Year 3 Monitoring Report

CATBIRD SITE

RE: Catbird Site: Year 3 Monitoring Report (NCDMS ID 100022)

Listed below are comments provided by DMS on November 15, 2021 regarding the Catbird Site: Year 3 Report and RES' responses.

Figure 2 - CCPV MY3

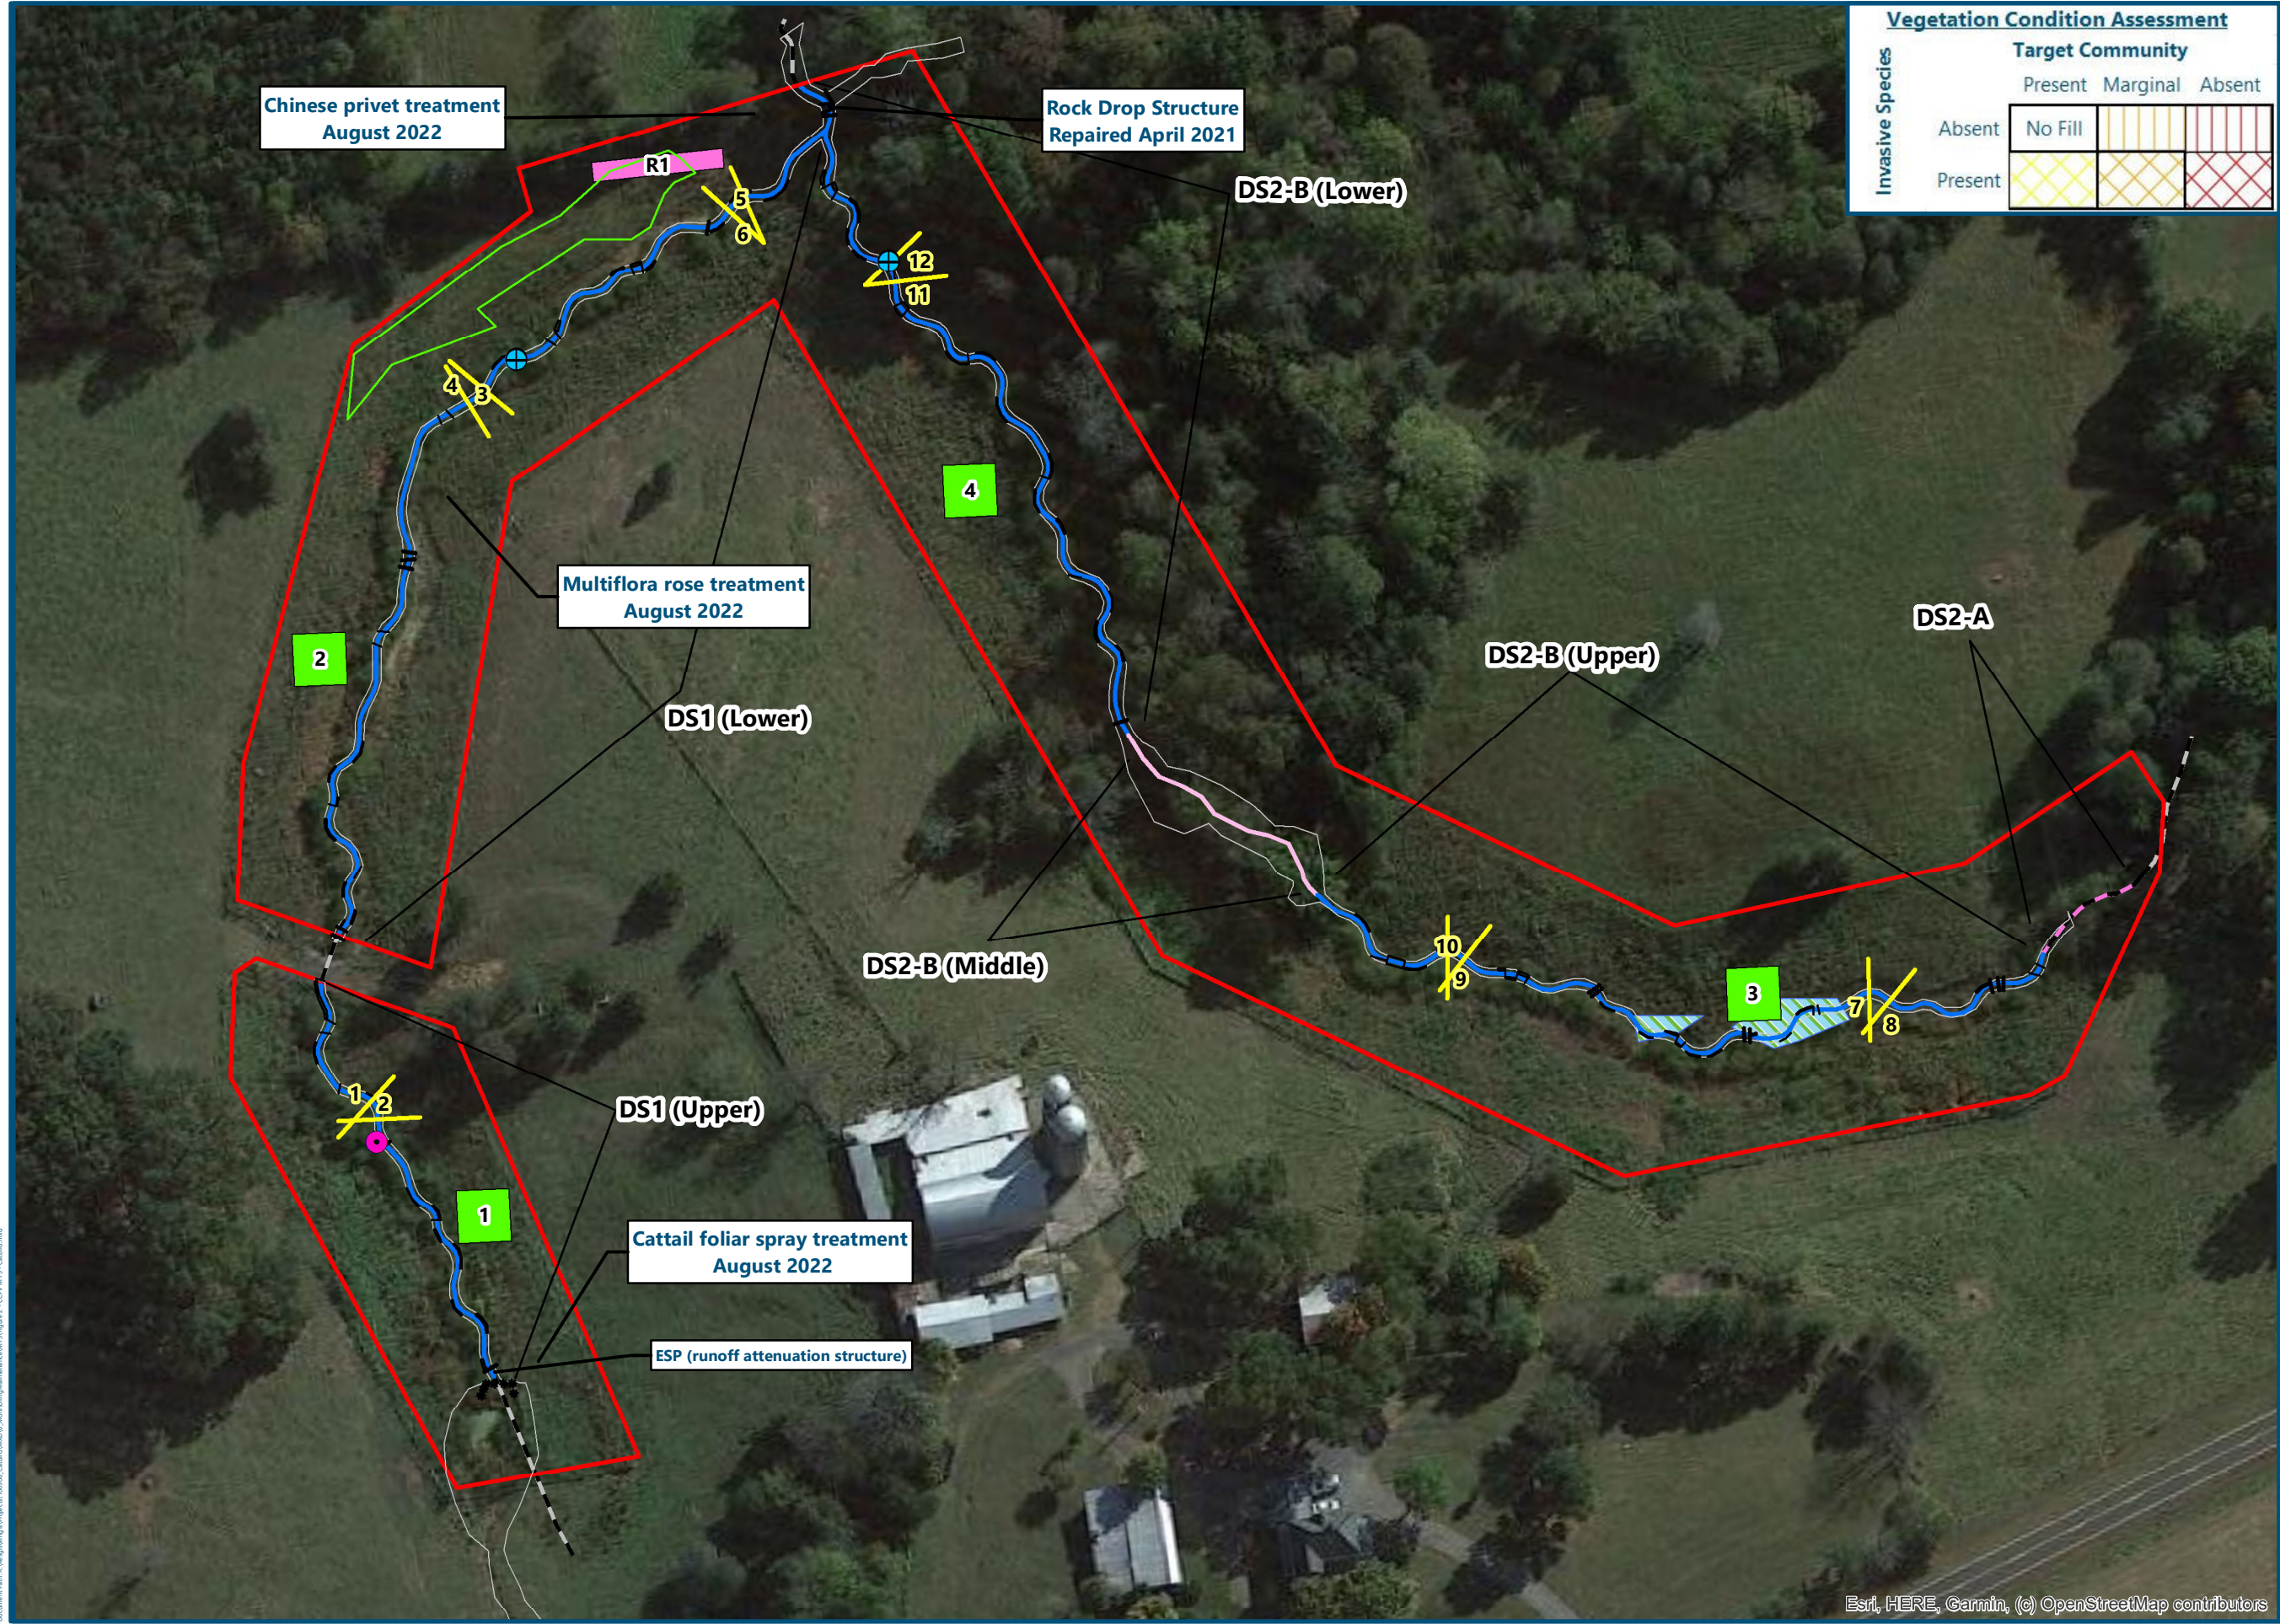
- CCPV – Supplemental planting area legend symbology (hatching pattern) does not match the apparent supplemental planting area on the CCPV.
[The CCPV planting area now symbology matches the legend.](#)

- Performance standard table (page 4) indicates that a runoff attenuation structure will be inspected semiannually; can RES indicate where this is on the CCPV, and give an update on the condition.
A callout for the runoff attenuation structure (ESP) can be found on the CCPV figure now. The ESP is functioning and remains stable.
- There is a rain gauge on-site next to the ambient, however rain gauge data was not reported. Please how RES plans to collect/report on site rain data moving forward.
The rain gauge was producing inaccurate and unreliable data and is no longer in use. It has been removed from the CCPV figure, RES is using NC WETS tables and North Carolina State Climate Office rainfall data to calculate precipitation data in the area.
- Please provide photos of the culvert along DS1.
Culvert photos have been added to appendix B.
